URBAN DESIGN REVIEW PANEL REPORT

Project:	2213 – 1657 Carling Avenue	Date:	01 October 2024
Hearing Date:	07 September 2023	Pages:	48
Comments Received:	10 October 2023		
File No.	PC2024-0317 / D02-02-24-0032

RESPONSE TO UDRP RECOMMENDATIONS

**URBAN DESIGN REVIEW PANEL
FORMAL SUBMISSION FOR
PRE-CONSULTATION REVIEW**

Figure 1: The maximum floor plate size of 750 sq m includes all built areas, such as dwelling units, offices, indoor amenity facilities, elevator cores, storage spaces, stairwells, hallways, etc., but **excludes inset or projecting balconies.**

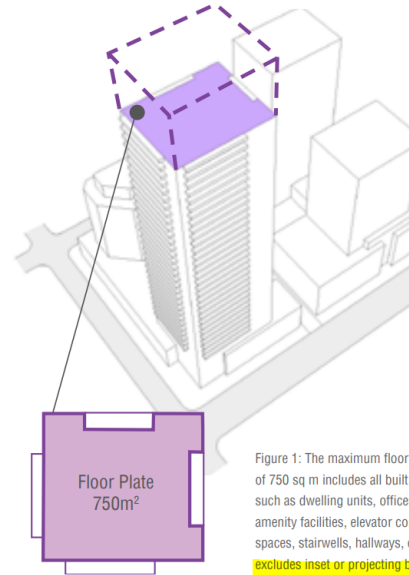
- *The Panel highly recommends the City's high-rise guideline of 750m² floorplates, inclusive of balconies, should be adhered to. As it stands, there is not a strong enough rationale for this project to be granted special consideration to this guideline.*
We understand that tall building guidelines are not standards but recommendations to be considered. We would question why a building that provides balconies would have a limitations on indoor space that a building without balconies would not face. Does this not encourage un-articulated buildings that are devoid of balconies? Is this the direction that is intended for high-rise buildings? I would also question why the 750m² floor plate includes balconies where the Toronto guidelines upon which Ottawa's were based does not.

3.2.1 FLOOR PLATE SIZE AND SHAPE

Limit the tower floor plate to 750 square m or less per floor, including all built area within the building, but excluding balconies.

1657 CARLING AVENUE FLOOR PLAN - GROUND FLOOR / CONCEPTUAL LANDSCAPE PLAN

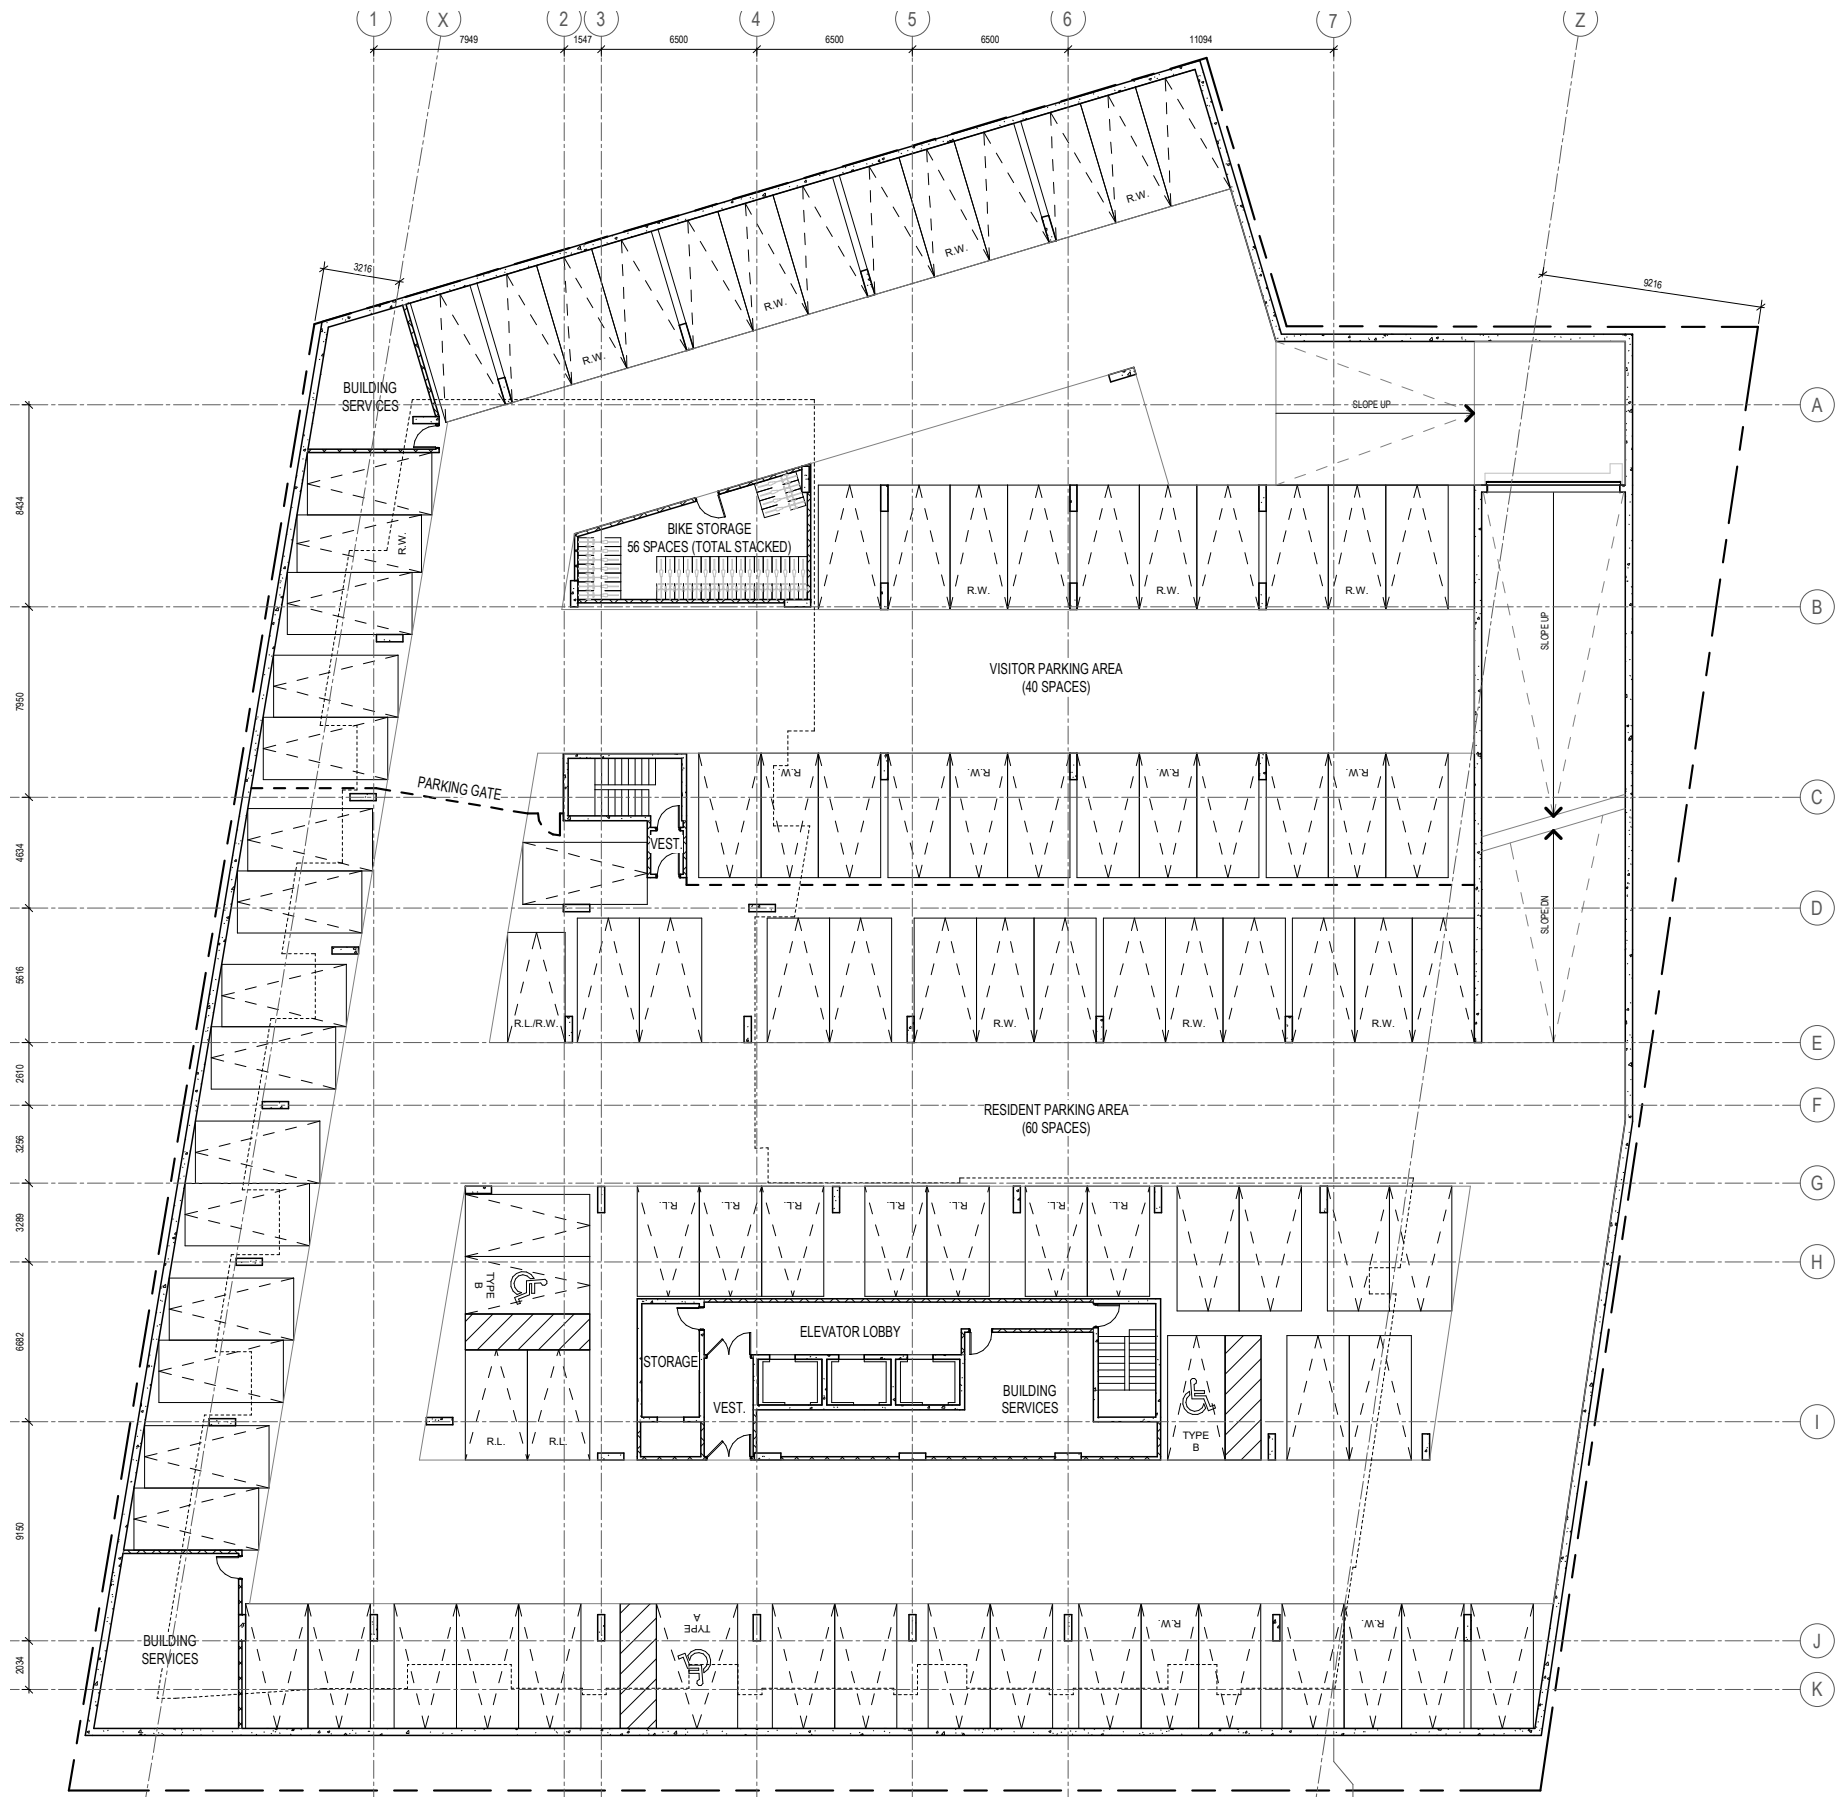
- *The Panel appreciates the description in the presentation of this parking area as a courtyard space, however what is currently proposed reads as a parking lot.*

- *Consider adding more landscaping in order to create a courtyard space. A lush courtyard space will also create a buffer from Tillbury Avenue. The courtyard design should be explored further in order to fulfill the description and intended vision for that space.*

- *The Panel recommends implementing a surface treatment in the ‘courtyard’ space that is more consistent with a pedestrian-first space.*

- *Consider blurring the lines between the pedestrian landscaped portion and the vehicular space by using paver treatments and landscaping as a means of creating a more pedestrian-first environment overall.*

- *Consider designing the forecourt area as a woonerf style courtyard.*

- *Consider reducing the number of surface parking spaces proposed.*

We are confused by this comment as we described in detail the landscaping shown in the design package. The building has a very generous setback from Tillbury in order to create a park space and this park is then carried into the courtyard of the building. This includes features such as raised planters, benches and other elements of outdoor furniture. Separating the parking from the ramp is another area of planting which is meant to obstruct the view of the ramp and will include small trees and taller shrubs.

While we have yet to complete a landscape plan, this will be done for the site plan control submission, where we will also provide more specifics of the specific planting being proposed to ensure that this space feels like a courtyard and not simply like a parking lot.

The specifics of the hard landscaping will be further developed during the site plan control submission, however there are concerns over cost and long-term wear related to using paving stones.

This can be considered as we develop the landscape design further.

We foresee a practical need for these surface parking spaces to properly serve the building. That said, we will look to see if we can remove one or two parking spaces in the future.
